Subject ▶ Change of Fan100, Hex. Lock Nut M8-13 and Spring Washer 8.

For Models ▶ HM 1800 (Electric Breaker)

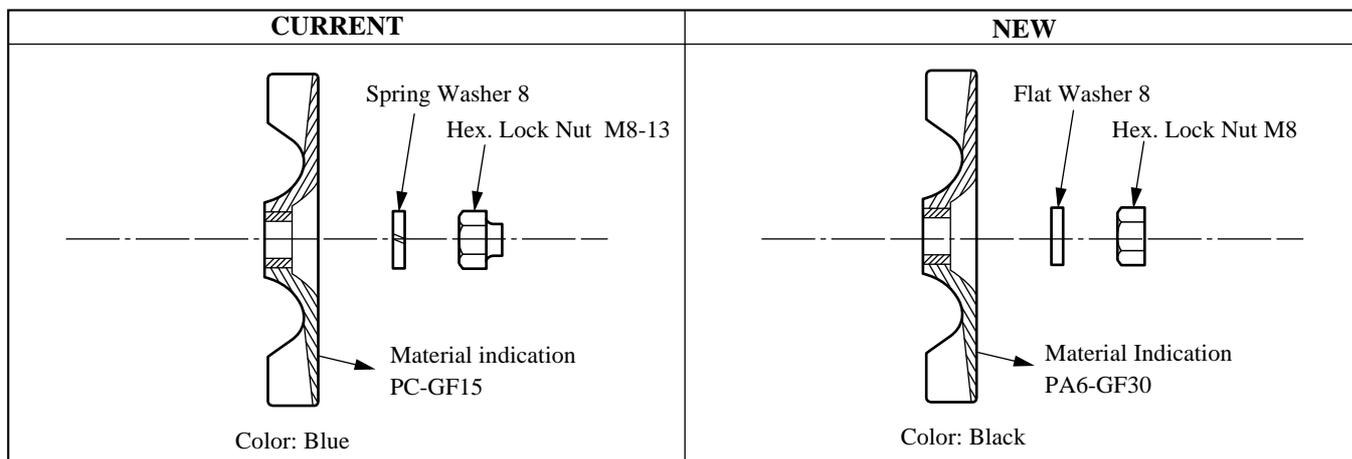
Description ▶ As illustrated below, Fan 100 has been changed.

The material of Fan 100 has been changed from Polycarbonate to Nylon, and Hex.Lock Nut M8-13 and Spring Washer 8 have been changed to Hex. Nut M8 and Flat Washer 8.

Item No.	Curret part	Q'ty	New part	Q'ty	I/C	Note
013	Fan 100 241854-8	1	Fan 100 240024-6	1	<=	
015	Hex.Lock Nut M8-13 252105-4	1	Hex. Nut M8 931402-8	1	<=	
014	Spring Washer 8 942201-3	1	Flat Washer 8 253165-9	1	<=

HM 1800:From Serial No. 13059E (Sep, 1998)
